TECHNICAL INFORMATION

TI1320

Alternative brewer valve HG-floor-standing machines

A&K Valve

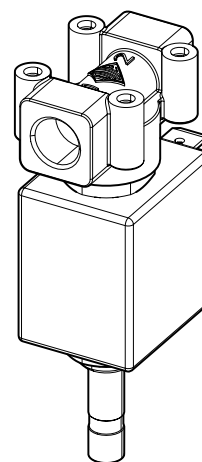
From production week 15/2020 to 22/20 A&K brewer valves instead of SFS valves have been fitted. Machines with serial numbers 90498820 to 90499235 have been fitted with the alternative brewer valves.

When ordering spares parts for machine serial numbers 90498820 to 90499235 part no. 409 00 940 00 SOLENOID VALVE 3/2 should be used. For other machines which do not fall into this time period part number 414 00 941 00 SOLENOID VALVE 3/2 should be used.
